## **2 SITE CHARACTERISTICS**

### **2.4 Hydrologic Engineering**

**Figure 2.4.13-1 PSEG Site Wide Water Levels September 2009, (from SSAR Revision 3, Figure 2.4.12-14)**

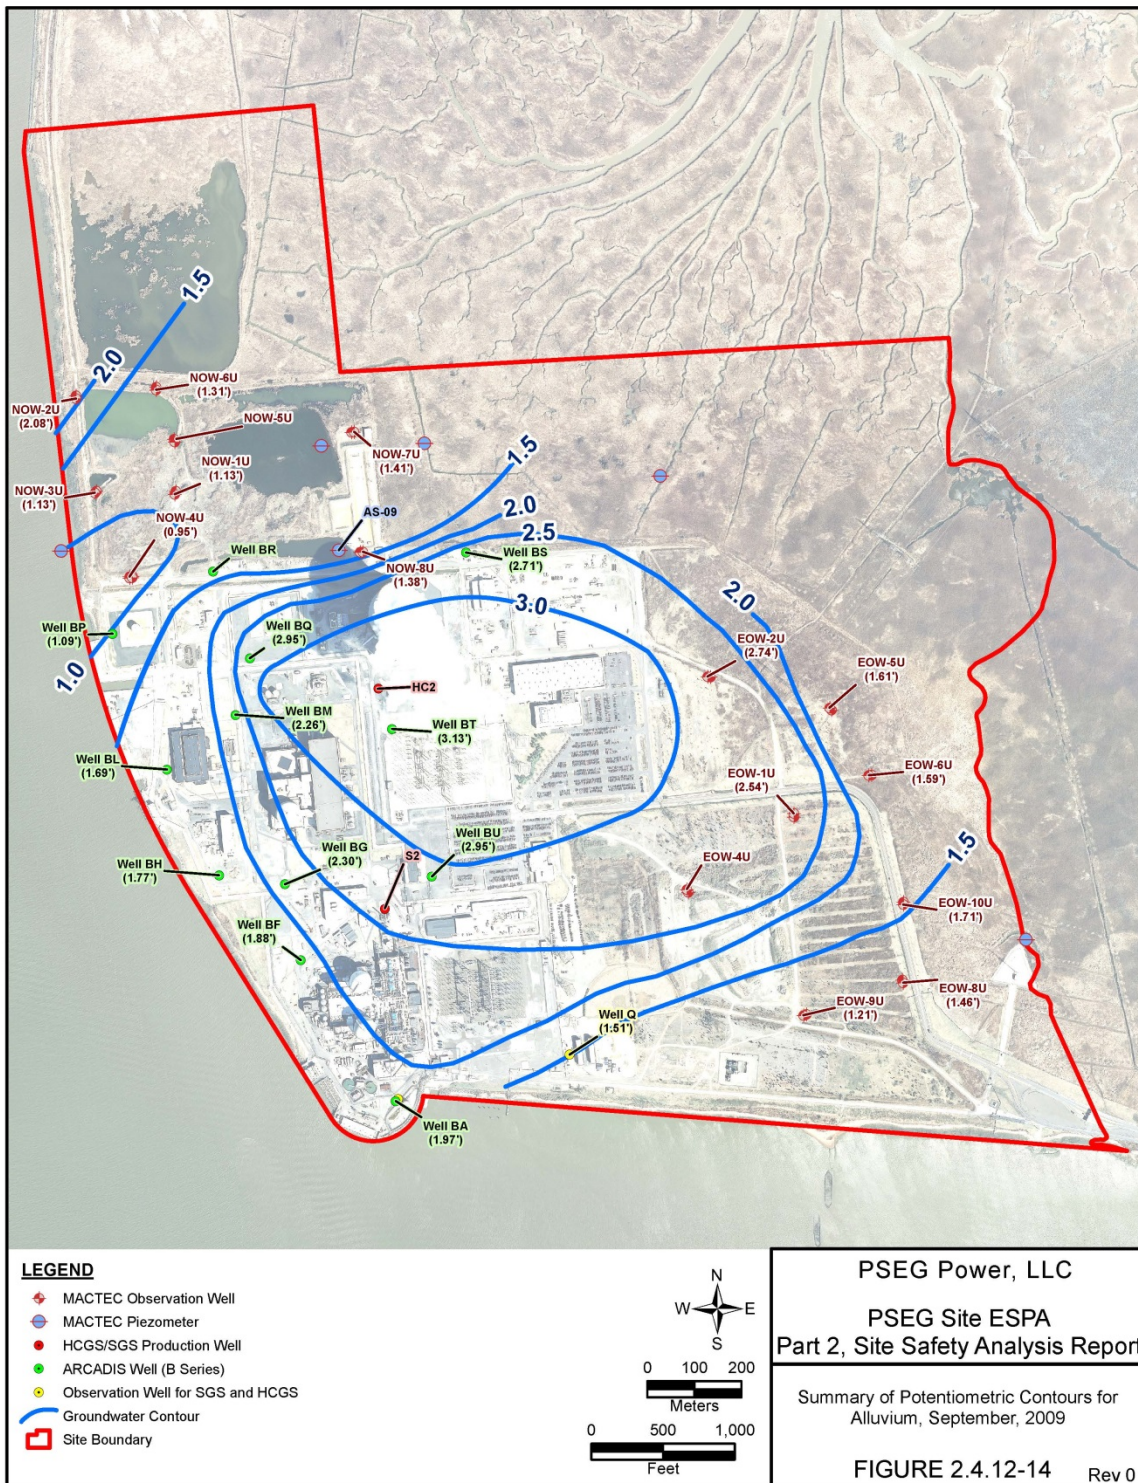
In RAI 31, Questions 02.04.13-5 (potential for release to the northeast) and 02.04.13-10 (conservatism of receptor locations), the staff communicated to the applicant concerns relating to a release toward the northeast, and requested that the applicant address these concerns. In a June 30, 2011, response, the applicant provided several qualitative arguments, summarized below, as to why a release toward the east side is the most conservative. The applicant also generated a site wide water table contour map (Figure 2.4.13-1 of this report) in response to RAI 29, Question 02.04.12-2, based on monthly water level data measured in 2009 to indicate predominant and sustained westerly groundwater flow across the PSEG Site with easterly components due to tidal fluctuation. These arguments for the conservatism of the westerly path noted that a substantially longer easterly travel time allowed for more radionuclide decay before discharge to surface water.

In a June 30, 2011, response to RAI 31, Question 02.04.13-10, the applicant explained that concentration attenuation factors in the accidental release scenario include sorption, decay, dilution, and dispersion vertically through migration into a lower, thicker aquifer. The release into the alluvium spans a relatively thin aquifer, whereas any further vertical migration into the next lower aquifer (the Vincentown) toward potential private well receptors (as well as the Delaware River) would be moderated by a longer flow path, additional dilution by dispersion, sorption, and added time for decay to occur which would indicate that migration through the alluvium is the more conservative pathway.
